A d d e n d u m

Iowa Department of Transportation
Office of Contracts

B.O.	Proposal ID	Proposal Work Type	County	Project Number	Addendum
309	97-0296-257	SANITARY SEWER	WOODBURY	IM-NHS-029-6(257)147--03-97	17JUN309.A01

SHEET NUMBER **D.9** REVISED

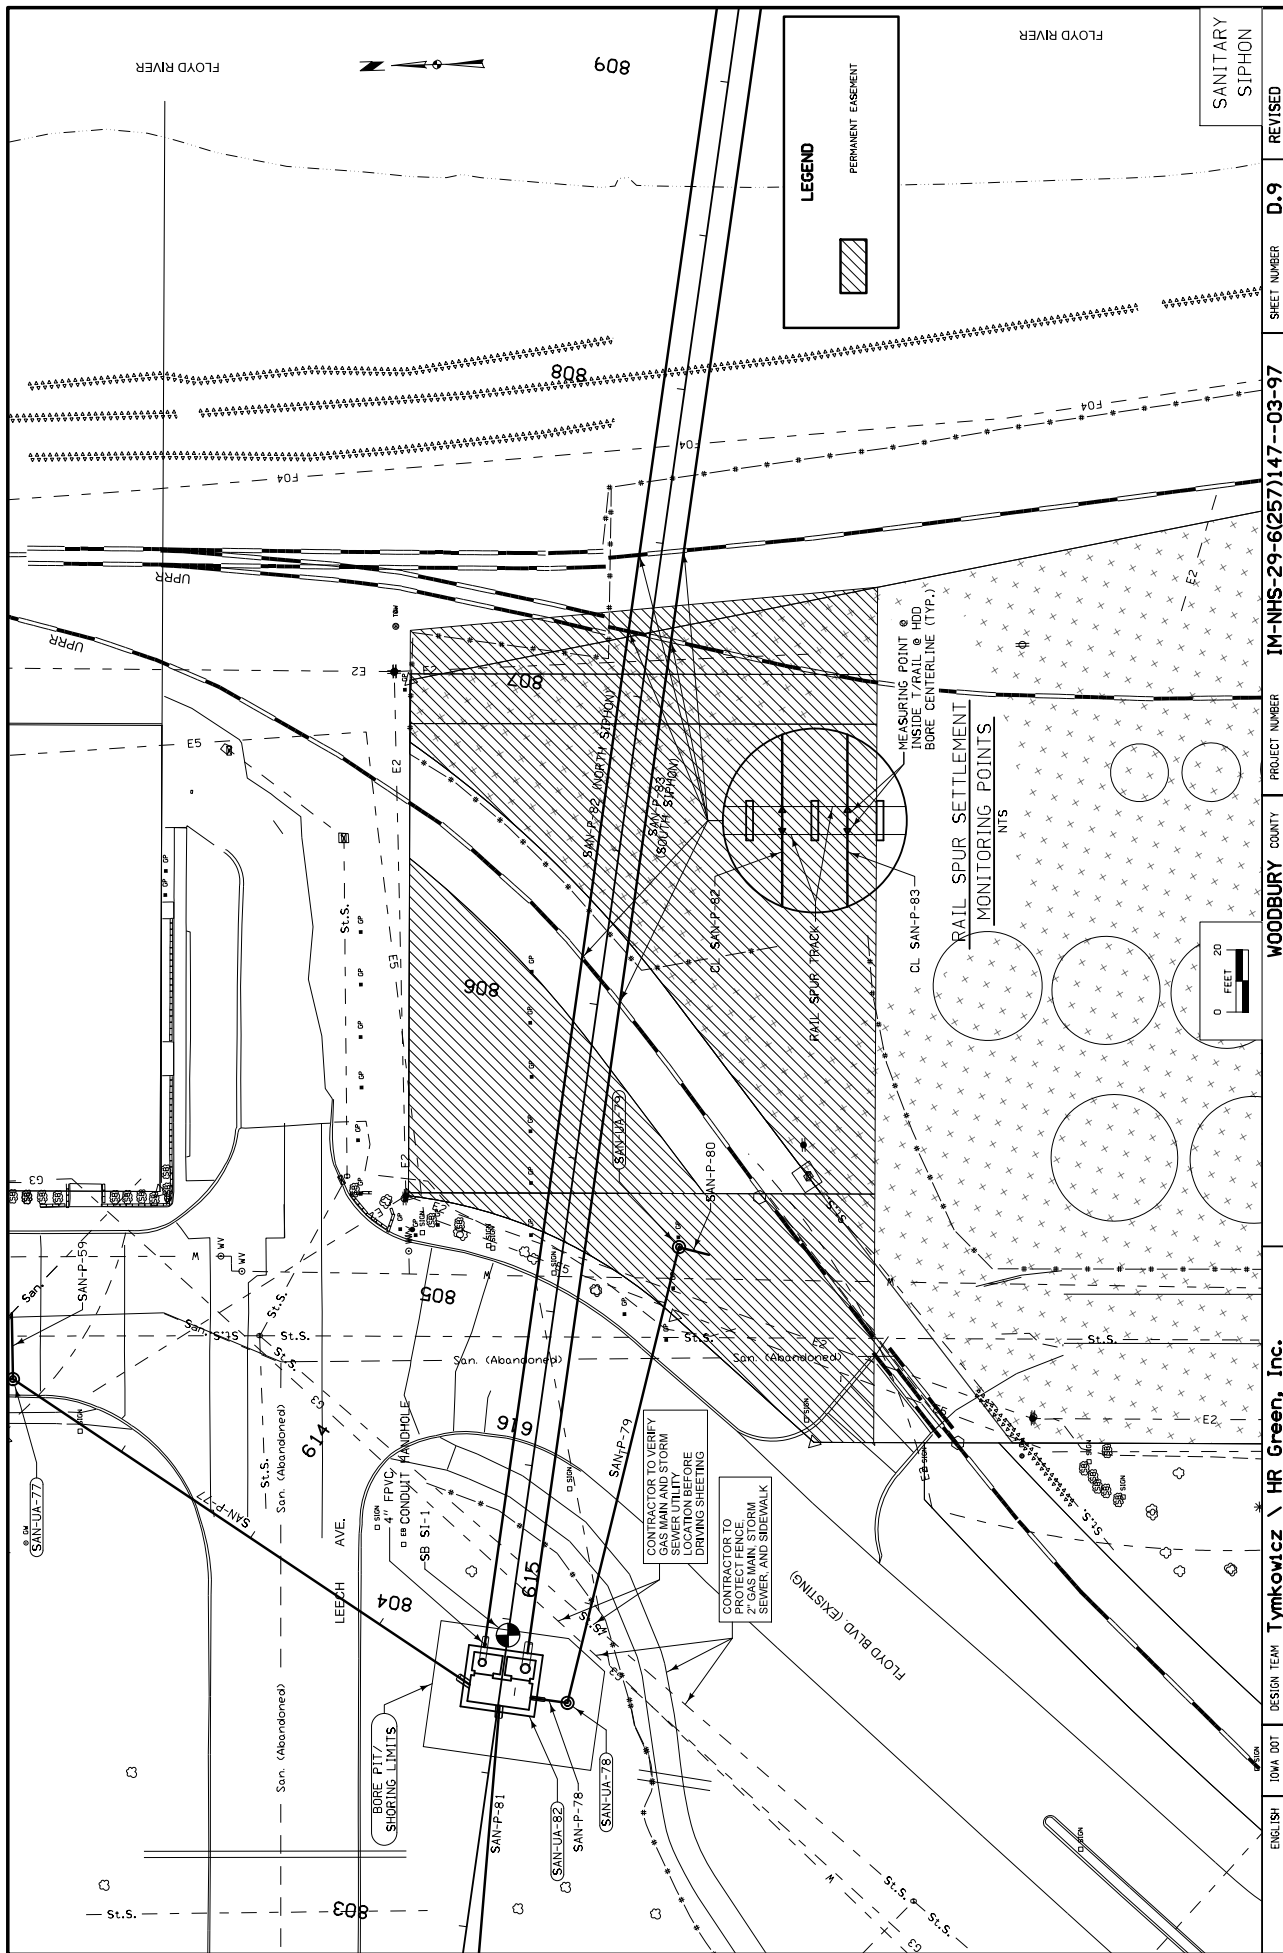
Replace SHEET D.9 with the attached SHEET D.9. Sheet was revised to hatch the permanent easement area east of Floyd Boulevard.

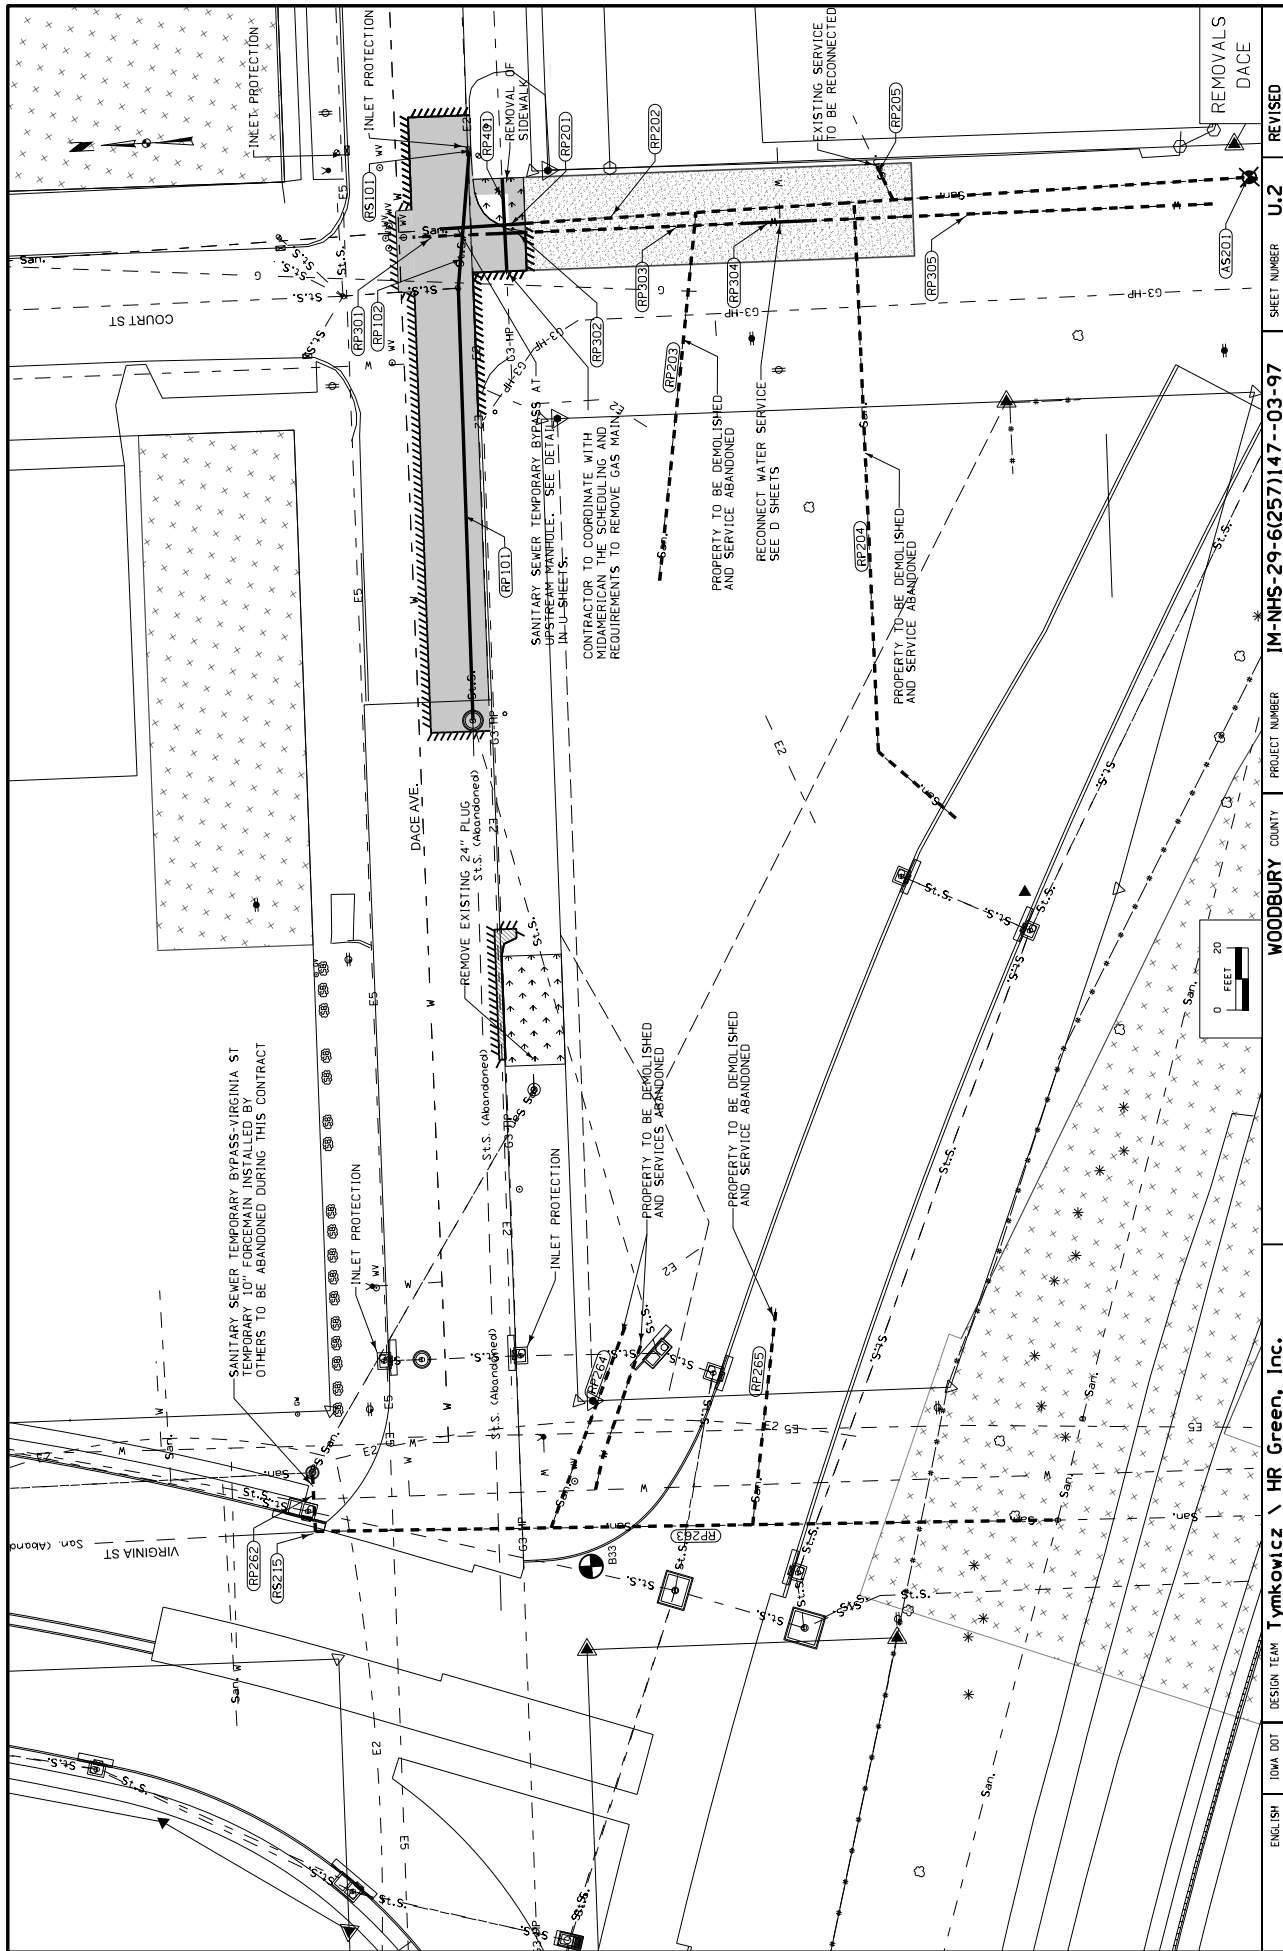
Replace SHEET U.2 with the attached SHEET U.2. Revised sheet deleted the abandonment of RP306 and the notes to install caps on the end of the hydrant/tee.
